PROJECT: 3090 Zone North Interim Tank

TECHNICAL DRAINAGE STUDY SUPPLEMENT
(Response to CLV Comments)

3090 Zone North Interim Tank

Subject: Supplement to the Response to CLV Comments to the Technical Drainage Study for 3090 Zone North Interim Tank (DS-4854)

Outlet Channel FlowMaster Calculations

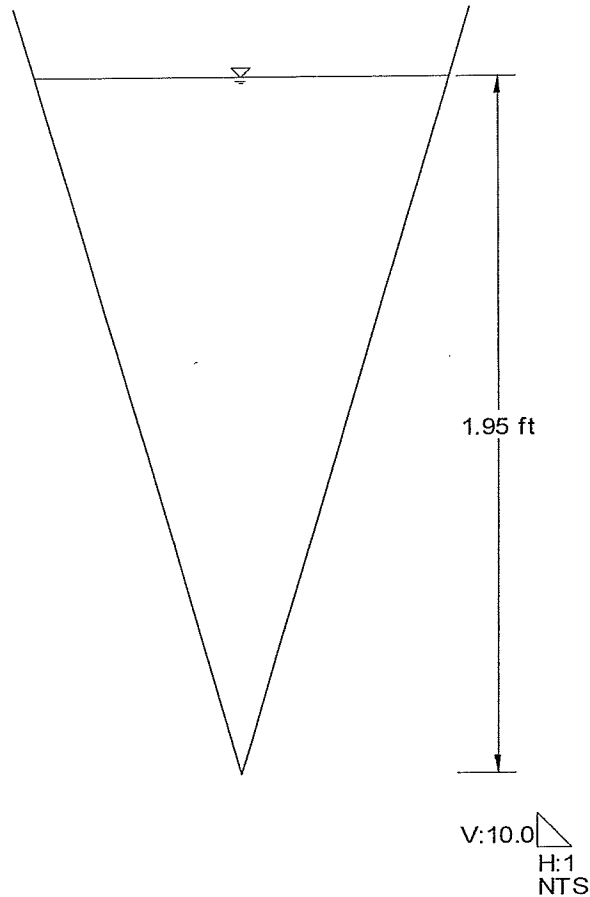
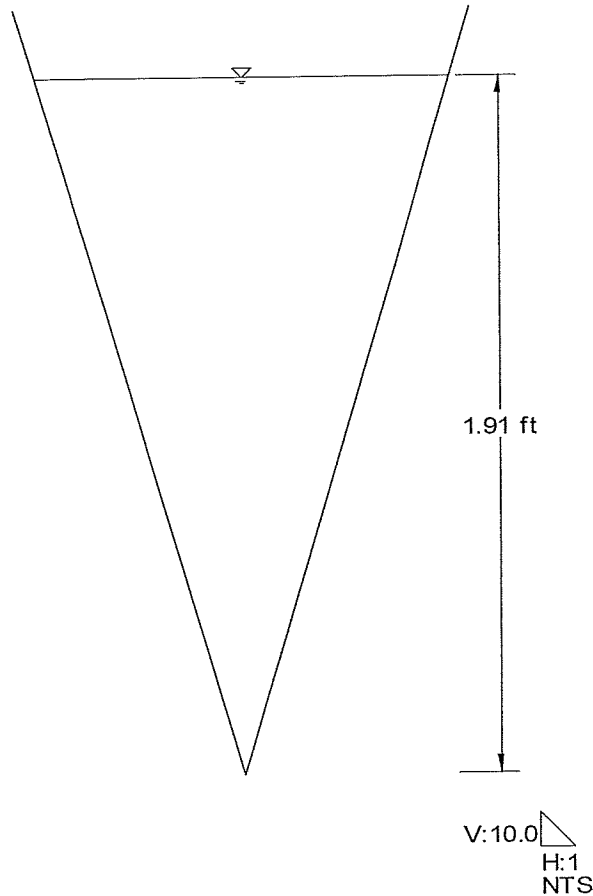
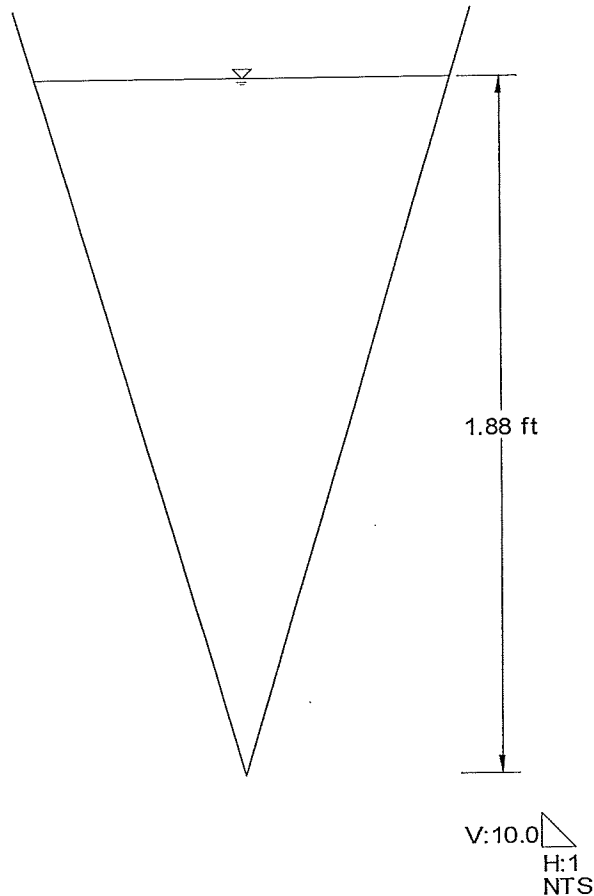
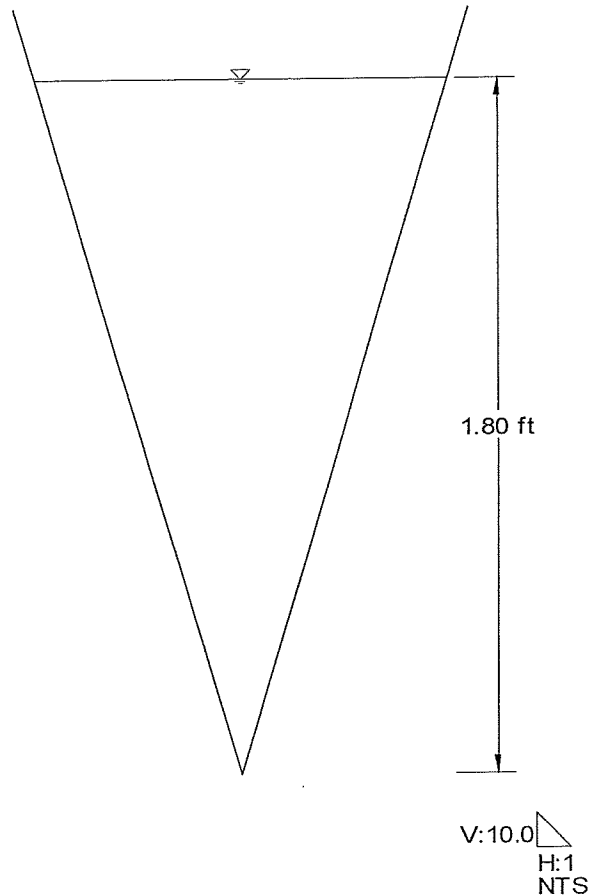
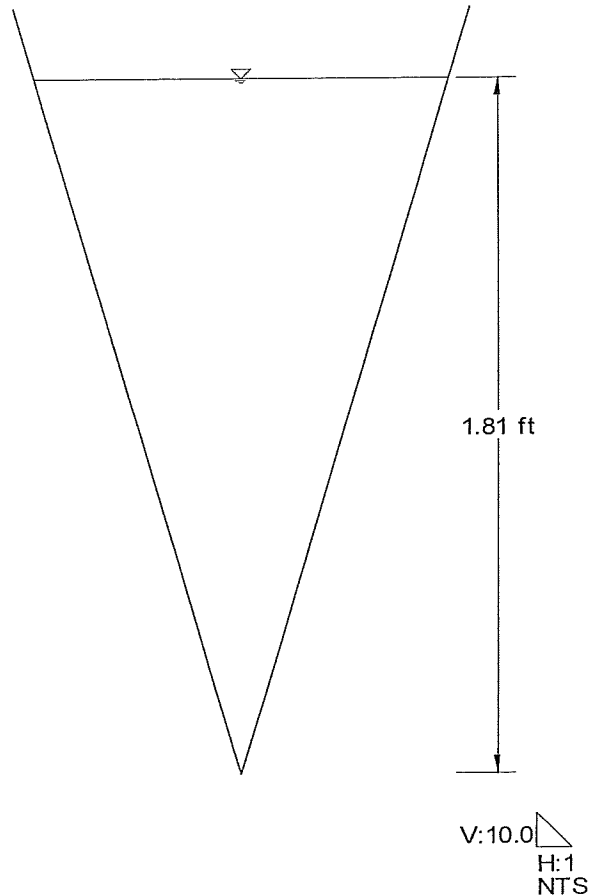
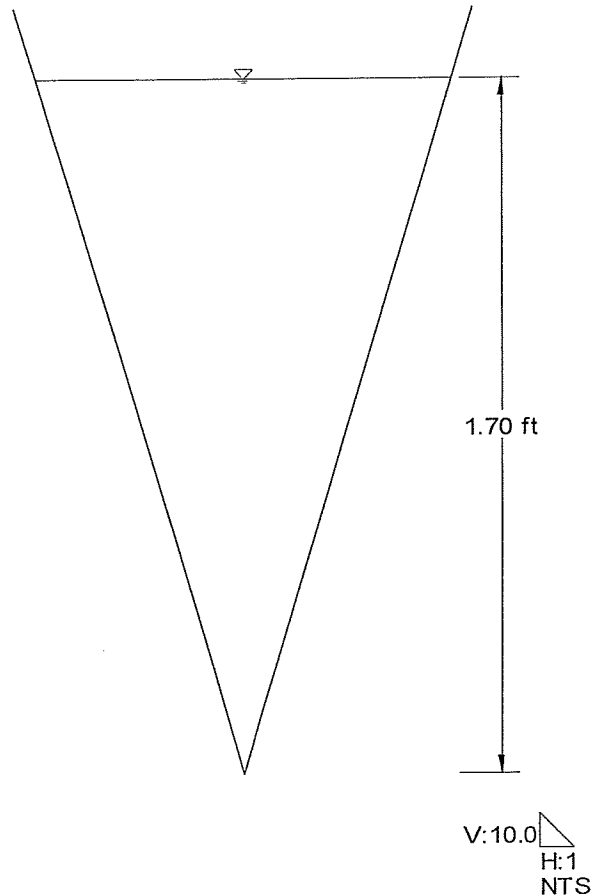
2. **Condition:** *Provide riprap sizing calculation for the access roadside channel in Centennial parkway to Flood Control Section prior to the final approval of the improvement plans.*

Response: Per varied revised slopes across the outlet channel, the riprap sizes have been listed in the table below.

Summary of Outlet Channel Riprap Size				
Station		Slope S	Flow Depth (ft) D	Design Riprap Size (inches) D ₅₀
02+50.00	06+50.00	5.30%	1.81	12
06+50.00	09+50.00	4.30%	1.88	12
09+50.00	10+50.00	8.20%	1.70	18
10+50.00	12+00.00	3.00%	1.95	12
12+00.00	14+00.00	5.80%	1.81	18
14+00.00	15+50.00	8.20%	1.70	18
15+50.00	END	3.50%	1.90	12

Riprap sizing calculations and supportive FlowMaster computations for each slope have been provided in Appendix B. Note that the revised slope and riprap sizes has had no effect on increasing the channel flow depth and remains within the 2-foot channel flow depth reported by the approved study.
